**INTERLOCAL AGREEMENT BY AND BETWEEN
THE CITY OF PLANO, TEXAS AND
NORTH TEXAS MUNICIPAL WATER DISTRICT
FOR REPAIR OF GABION STRUCTURE – ARBOR HILLS NATURE PRESERVE**

TO: NTMWD - Amin Tehrani PhD, PE; Scott Hoelzle PE
CC: City of Plano - Courtney Vanous, MES, REM, CESSWI
FROM: Stephen Norair II, PG; Jonathan Swchwartzenberg, PE, CFM; Keith Byrne, PE, CFM
SUBJECT: Design Recommendation - Arbor Hills Gabion Drop Structure Repair & Improvement
DATE: 12/22/2025
PROJECT: NTD25058/PLA24018

Table 1. Rock Riprap Size Gradations used in Gabion Drop Structure Repair and Improvements

Exhibit 1 - Proposed Repairs & Improvements
N.T.S.

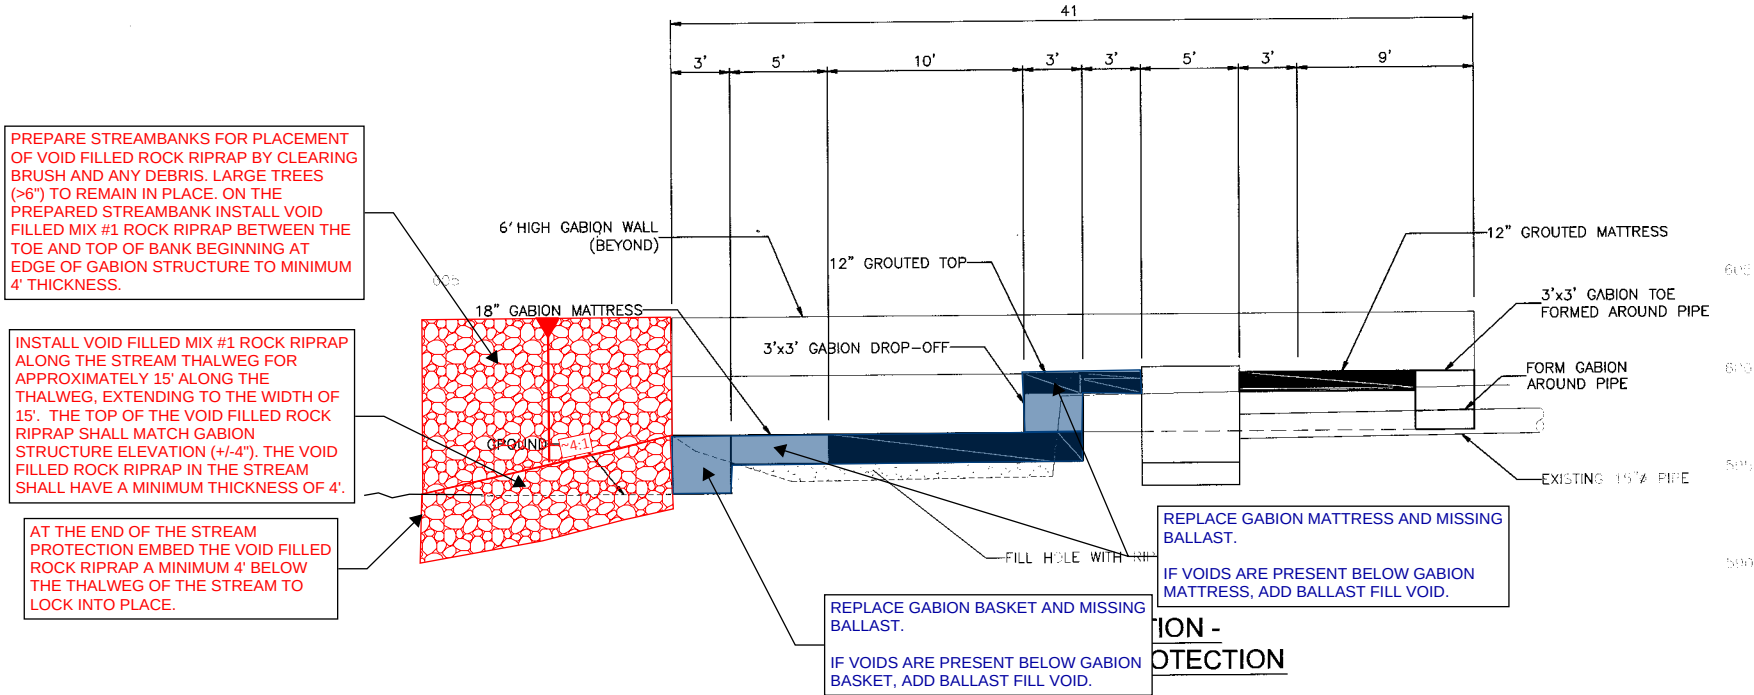
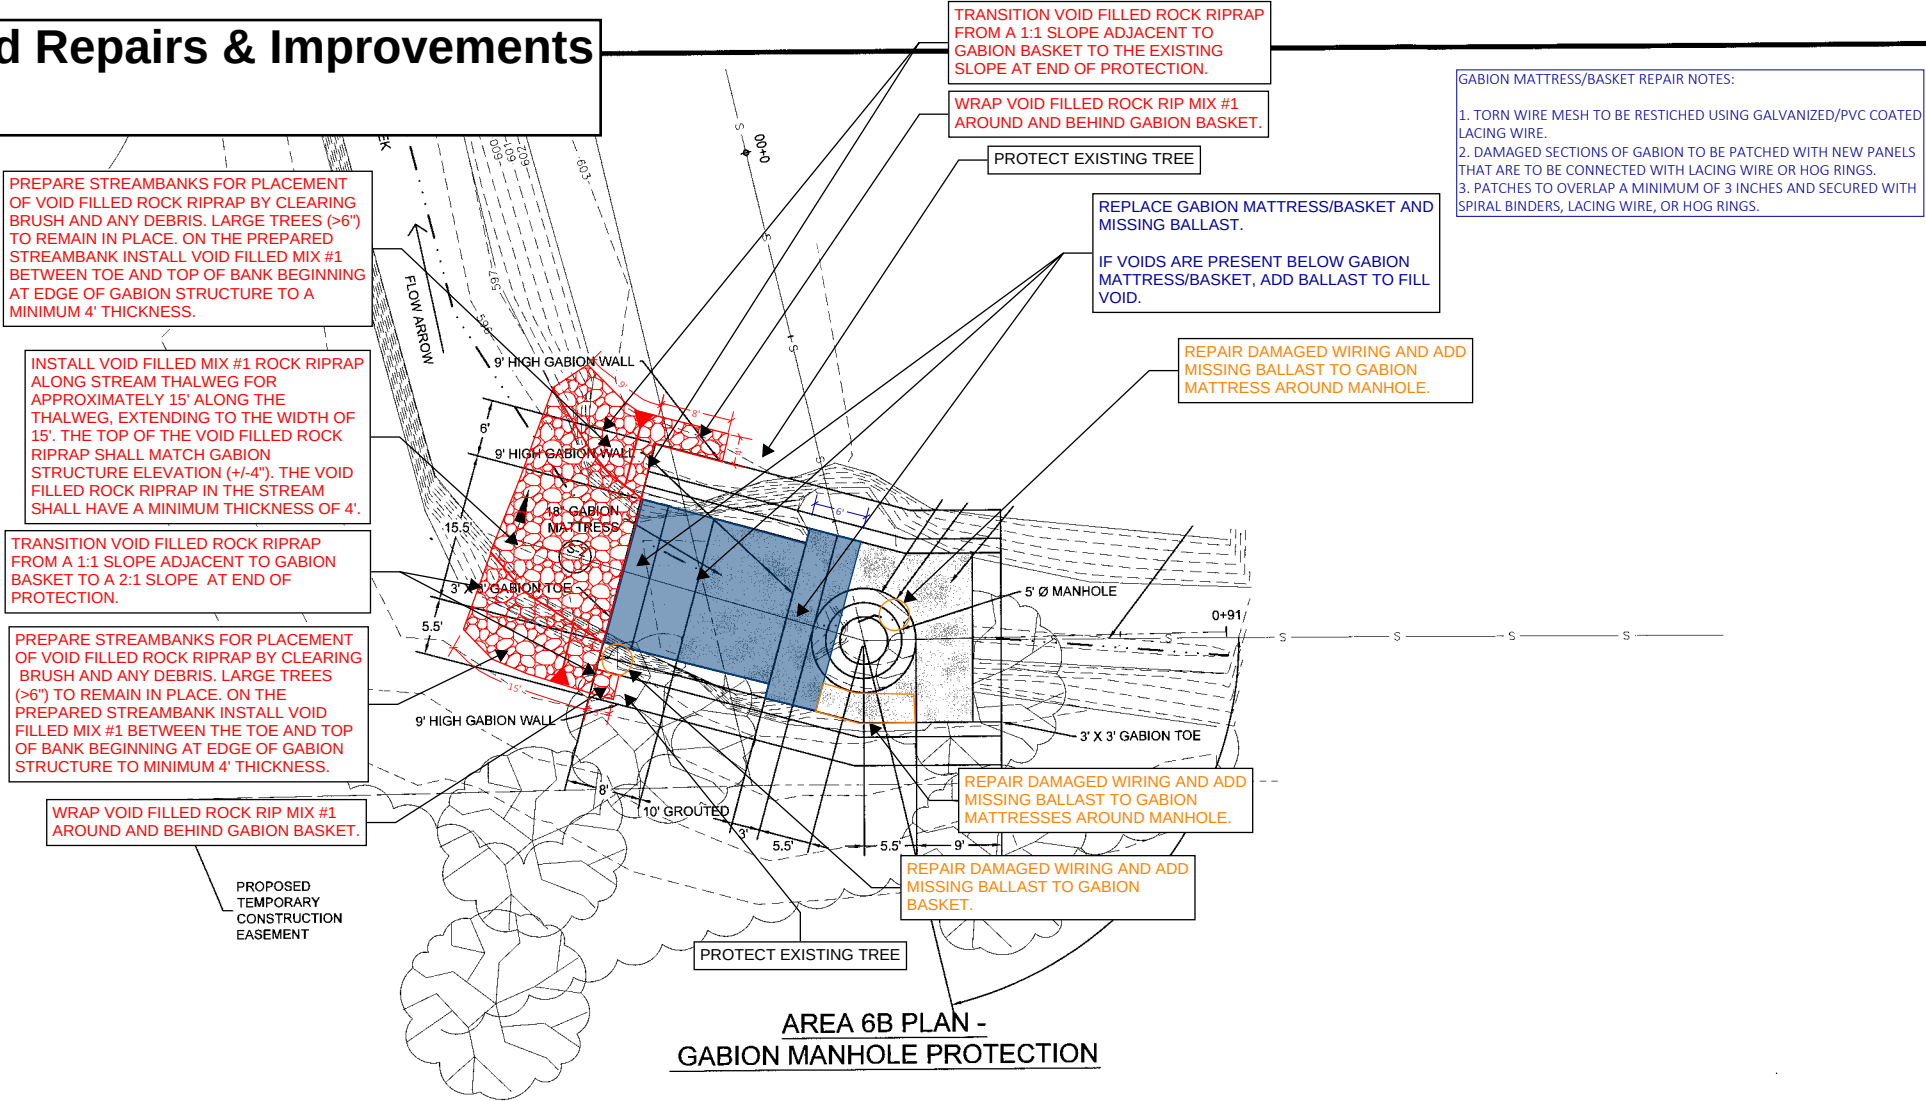
The design approach to repair and improve the gabion drop structure is listed below. These items are also shown on **Exhibits 1**, which overlays the additional rock riprap protection measures over the construction detail from the original gabion drop structure plan set, which overlay the proposed improvements over site photos. The proposed repairs do not address the fundamental stresses that are inherent to this reach of stream. It is suggested that the site be monitored and it should be expected that repairs will be needed in the future.

- Repair damaged gabion basket and mattress wiring and replace missing ballast as needed. Replace failed gabion mattresses and basket. If a void is present beneath replaced gabion mattresses or basket fill voids with gabion ballast. The location of the gabion structure repairs are shown on **Exhibit 1**.

- a. Void Filled Mix #1 should extend from the toe of the streambank and tie into the top of the streambank and wrap around the gabion basket as shown in **Exhibit 1**.

- b. Void Filled Mix #1 should begin at the downstream edge of the gabion structure and continue downstream as shown in **Exhibit 1**.
 - c. The Void Filled Mix #1 should have a minimum thickness of 4 feet.

2. Prepare the left and right streambanks for the placement of rock riprap by clearing brush and any debris. Large trees (>6") to remain in place.
3. The rock riprap protection used is called "Void Filled Rock Riprap". This material created on site by mixing the gradations shown on **Table 1**. On-site mixing of larger and smaller gradations results in a rock riprap where the grains can lock together to provide a more erosion resistant protection measure than traditional rock riprap which contains pore space between individual grains.

- a. Void Filled Mix #1 – To make Void Filled Mix #1, mix:
 - i. 2 loader buckets of Rock Riprap Type "E"
 - ii. 1 loader bucket of Rock Riprap Type "F"
 - iii. 1 loader bucket of Stone Bed Material (ASHTO #57)

- b. The resulting mix has minimal voids between individual grains.
4. Place Void Filled Mix #1 (described in Step 3) along the stream thalweg:
 - a. Void Filled Mix #1 should extend across 15' for approximately 15 feet downstream of gabion structure.

- b. The top of the void filled rock riprap shall match gabion structure elevation (+/-4").
 - c. The void filled rock riprap in the stream shall have a minimum thickness of 4'.

- d. At the end of the stream protection embed the void filled rock riprap a minimum 4' below the thalweg of the stream to lock into place.
 5. Place Void Filled Mix #1 over the prepared left and right streambank:

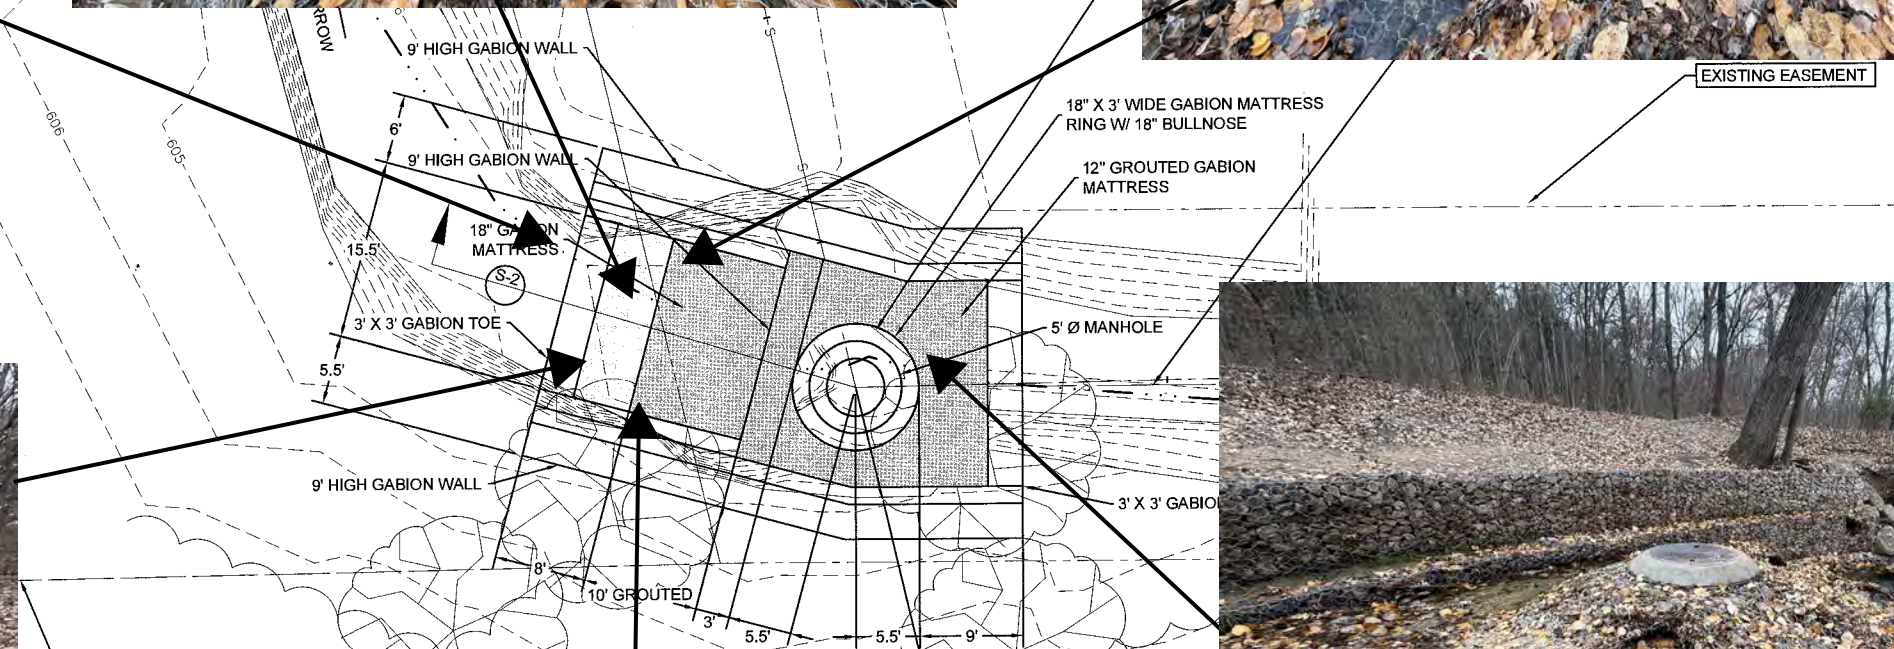
Damaged/failed gabion mattresses and gabions.

Damaged gabion mattresses and gabions. Scour on downstream left bank.

Scour on downstream edges of structure. Failed gabion mattress

Failed gabion mattress

Damaged gabion mattresses and gabions
